Technical Service Bulletin

TSB1418
Strain Relief Throttle Cable to Carb on CX50

This applies to all Cobra CX50’s

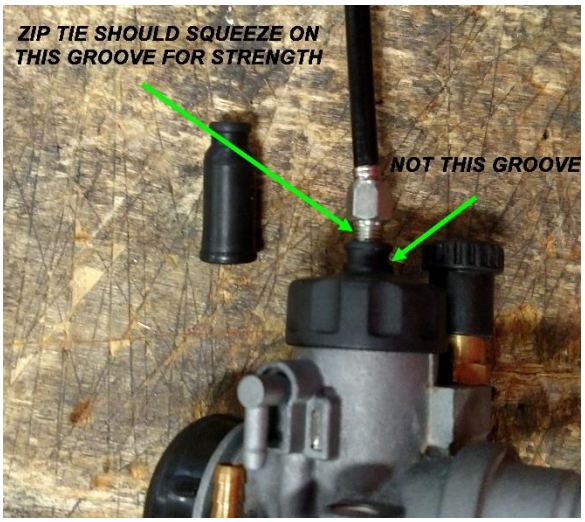
To reduce the likelihood of the throttle cable being pulled from top of the carburetor it is recommended to install two 8” zip ties as shown in the pictures below to strain relief the throttle cable to the carburetor top. One zip tie securing the boot to the cable the other securing it to the threaded cable adjuster.

NOTE: For the strongest grip, the bottom (left in the pictures) zip tie should be squeezing on the groove between the hex adjuster and the top, NOT the groove in the carb top.
